Ţ	H Affordet 316 319 318 For correct identification of the types concerned refer to the basic numbers shown in the index of Service Bulletins(page 1).	
inpolind en Frence <u> </u>	N° 05.68 CLASSIFICATION SUBJECT : <u>TIME LIMITS</u> Check of angular displacement on the output flange of the	
₿₩∐∐	Main Gear Box	
	Corresponds to modification : Not applicable OFFICIAL APPROVAL October 3, 1980	MANDATORY
VICE+	REMARKS This Service-Bulletin is the subject of the : - 40 th Airworthiness Instruction ALOUETTE II and of the - 42 nd Airworthiness Instruction ALOUETTE III	
SER 1		
	۔ N [°] 05.68 Date : October 3, 1980 Page : 1

SERVICE BULLETIN

C - DESCRIPTION (see Figure 1)

BEVEL GEAR AND FLARED STUB SHAFT ASSY FIGURE 1

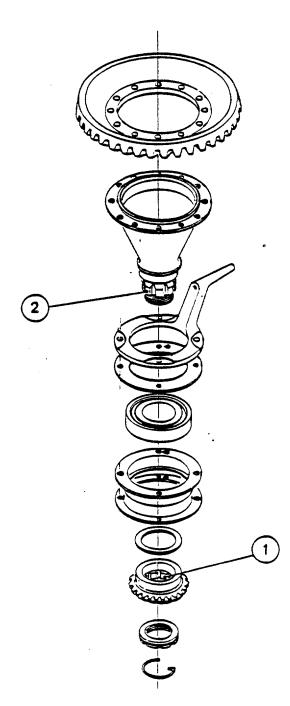
Because of an excessive wear found in service at the splines coupling the lower bevel pinion for tail rotor drive (item 1) and the bevel gear flared stub shaft (item 2), it is necessary to check the play by measuring the angular displacement on the output flange of the MGB.

- Apply the rotor brake
- Install a dial gauge (on a part stationary in relation to the M.G.B.) and rest the feeler of the gauge on one flat of the head of a bolt securing the M.G.B. output flange to the inclined drive shaft flange
- By hand, rotate the inclined drive shaft in both ways (fully against stop)
- Read the total displacement «d» on the dial gauge.

- If the displacement $\langle d \rangle$ is ≥ 1 mm, remove the M.G.B. for overhaul in a qualified workshop.
